Office of
Environment
& Heritage

RE: OEH SUBMISSION FOR THE WALLARAH 2 COAL PROJECT (SSD_4974)

OEH review of the Wallarah 2 Coal Project (SSD_4974) in relation to threatened biodiversity, heritage, flooding and surface water management and environmental impacts resulting from subsidence.

Figure 2. Correlation between Predicted Total Closure and Total Upsidence from the Bulli Seam PAC Report (left) and Dendrobium 3B MSEC 2102 Report (right).

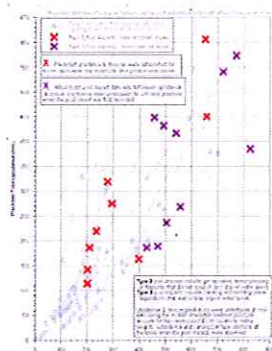
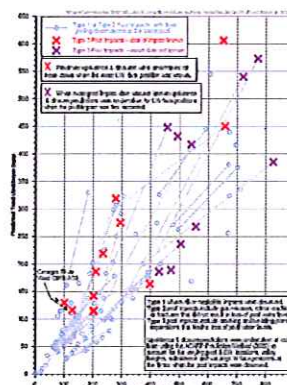
OEH previously commented that it would prefer to focus assessments of potential impacts of non-conventional subsidence on the basis of maximum observed/predicted closure strains. Closure movement (in mm) but not closure strains (mm/m) are detailed in the subsidence assessment. As an illustration of OEH's previous concerns about the valley closure >200 mm threshold, Figure 2 illustrates the upsidence and valley closure graph that appeared in the Bulli Seam PAC review report and the most recent iteration of this graph provided in MSEC (2012). It is clear that Type 3 pool impacts have now occurred at total closure levels well below 200 mm in the Upper Georges River as a result of West Cliff LW33 operations (where the panels did not go directly underneath the river). It is also worth noting that neither of the graphs included the experiences at Waratah Rivulet WRS3/Pool A (Arthur Waddington pers comm. 2012) where Galvin & Associates (2005) identified major pool/rockbar impacts with measured upsidence of only 60 mm.

While there are clearly geological differences between the Wallarah 2 and the Bulli Seam Project Areas, it is highly speculative to suggest that any impact will automatically be lower at Wallarah 2. If the subsidence predictions in MSEC (2013) are considered for the major streams above the Wallarah 2 proposal, many of these predictions considerably exceed the subsidence thresholds used by the Bulli Seam PAC to predict potential negative environmental consequences. Maximum tensile stresses for Jilliby Jilliby Creek, Little Jilliby Jilliby Creek, Armstrong Creek and Myrtle Creek range from 2.25 mm/m to 4.2 mm/m (in some cases over eight times the 0.5 mm/m PAC threshold for rock fracturing). Maximum compressive stresses for Jilliby Jilliby Creek, Little Jilliby Jilliby Creek, Armstrong Creek and Myrtle Creek range from 3 mm/m to 5.55 mm/m (in some cases almost six times the 2 mm/m PAC threshold for rock fracturing). Maximum valley closure levels for Little Jilliby Jilliby Creek, Armstrong Creek and Myrtle Creek range from 775 mm to 1000 mm (up to five times the industry suggested impact threshold of 200 mm and highly likely to cause fracturing in incised river valleys). Maximum upsidence levels for Little Jilliby Jilliby Creek, Armstrong Creek and Myrtle Creek range from 650 mm to 800 mm (also highly likely to cause fracturing in incised river valleys).

Overall, approximately 19.6 kilometres of 3rd order or above streams are predicted to experience upsidence > 60 mm (approximately 13.7 kilometres of streams with predicted upsidence > 100 mm; see **Appendix 1**). Approximately 12 kilometres of 3rd order or above streams are predicted to experience valley closure > 100 mm (approximately 10 kilometres of streams with predicted closure > 200 mm; see **Appendix 1**). This is not a trivial extent of potential impact and highlights the risk of serious adverse consequences of both conventional and non-conventional subsidence on the 3rd order and above streams lying above the project area.

Figure 3. Faults, synclines and lineaments identified within exploration area including those detected in boreholes (red circles). Source: WAJCV and Mauger et al 1985.

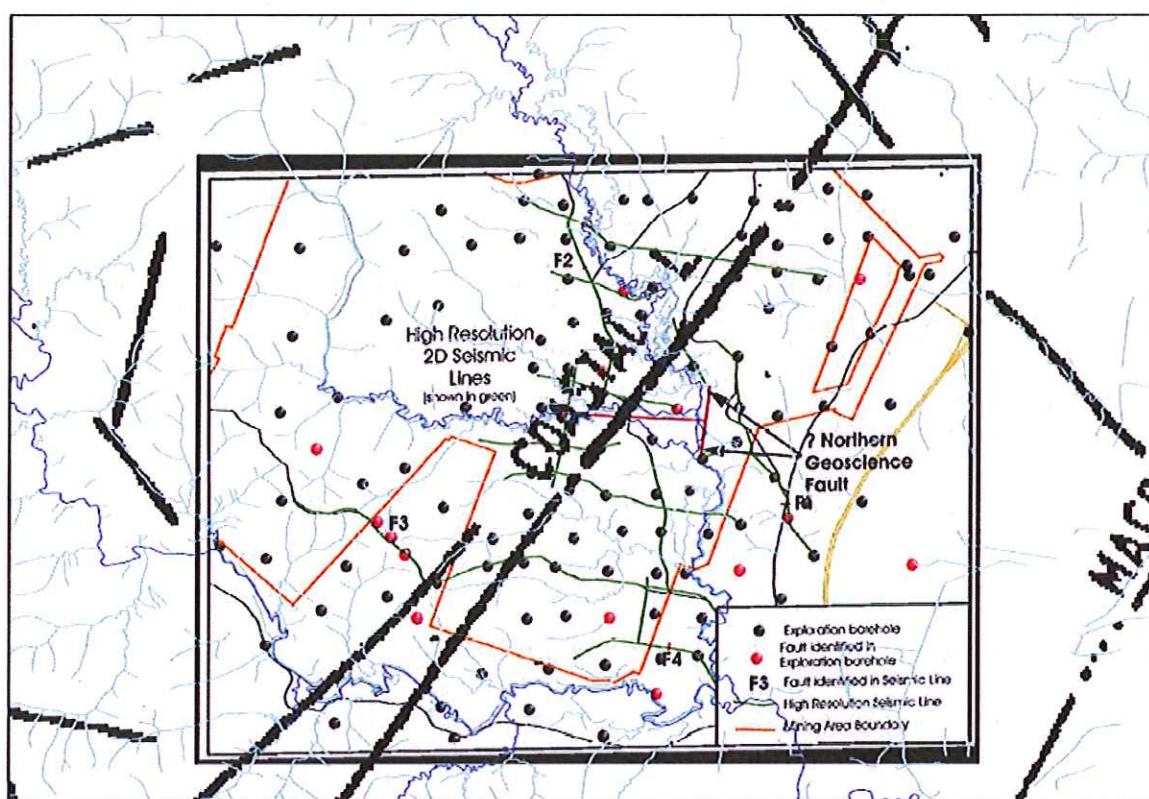
In response to previous comments on the potential for faults to affect subsidence within the Project Area, the EIS now has a specific volume dealing with Geology (WACJV 2013 Appendix C Geology). This report confirmed the existence and location of the Macquarie and Yarralong synclines, but found no support for the 'Coastal Lineament' proposed by Mauger et al (1985) or the 'Northern Geosciences Faults' proposed by Jones (2005). Figure 7.4 of the Geology Report illustrates the lineament and faults (and proposed lineaments and faults) as well as exploration boreholes. It is clear from Figure 7.4 that there have been no high resolution seismic investigations undertaken in the western region of the project area (i.e. near or within Jilliby SCA).

In previous discussions with the proponent about the potential impacts of faults, OEH was provided with a similar figure to Figure 7.4 which also highlighted faults identified within exploration boreholes (see Figure 3). OEH considers Figure 7.4 of the Geology report to be misleading in not additionally identifying the faults within exploration boreholes, some of which are very close to the major streams within the Project Area. The potential for these faults to increase the risk of impact to significant streams receives virtually no attention in the EIS. If a discussion of faults is to be presented in the EIS, all relevant information, including the location of faults identified within exploration boreholes, should be documented, clearly presented and assessed for their potential to impact major streams within the Project Area. This has not occurred.

Figure 4. Low flow records for Jilliby Jilliby Creek (Stn 211010).

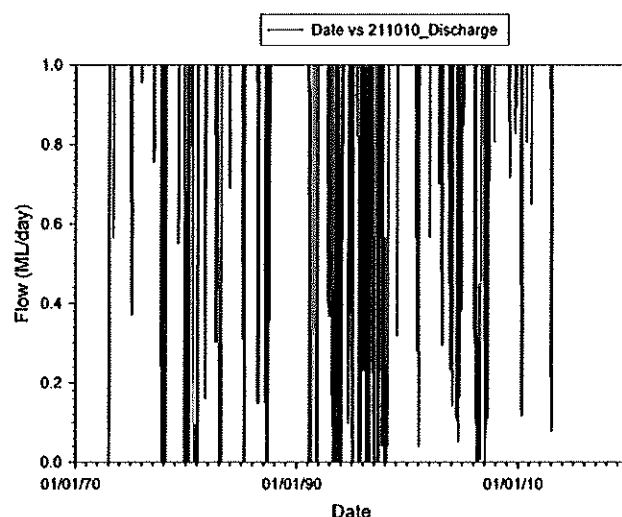
While OEH can agree with the use of the 'ephemeral' term for the majority of 1st and 2nd order streams in the more mountainous areas, OEH disputes the use of the term "ephemeral" to describe third order and above streams (including Little Jilliby Jilliby Creek) over the project area. Indeed if the flow duration curves for Wallarah Creek (Stn 211006) and Jilliby Jilliby Creek (Stn 211010) presented in WRM (2013; Figure 2.19) are considered, it is clear that Wallarah Creek had no flow for approximately 19 per cent of the time period with recorded flows and Jilliby Jilliby Creek had no flow for approximately five per cent of the time period with recorded flows. This is clearly not indicative of an "ephemeral channel that flows only for hours or days following rainfall". As a further illustration of this point, if the low flows for Jilliby Jilliby Creek are analyzed in greater detail (particularly during the 2000 - 2008 Millenium drought; see Figure 4), zero ML/day flows were recorded in Jilliby Jilliby Creek on only seven occasions and flows less than 0.01 ML/day on 31 occasions over the last 12 years. The low flows in Figure 4 in earlier years may actually be indicative of an interaction between low flows and extractive use within the Jilliby Jilliby catchment. It is difficult to reconcile these low flow numbers with MPR's (2013) discussion of baseflows in Jilliby Jilliby Creek, particularly the statement that:

The use of ill-defined and misleading terminology (i.e. ephemeral) to describe third order streams and the lack of any flow data other than that provided by the NSW Office of Water gauges, points to an inadequate assessment of flows overall for the Wallarah 2 proposal. It is clear that no targeted flow data has been collected for Little Jilliby Jilliby Creek, Armstrong Creek or Myrtle Creek or recent flow

data for Wallarah Creek (last record from the old NSW Office of Water gauge was July 1976). It will therefore be impossible to verify/validate subjective assertions of 'no impact' on streamflow throughout the majority of the project area. In particular, there is no capacity to assess any change to the frequency of cease to flow periods for any major stream other than Jilliby Creek or the Wyong River.
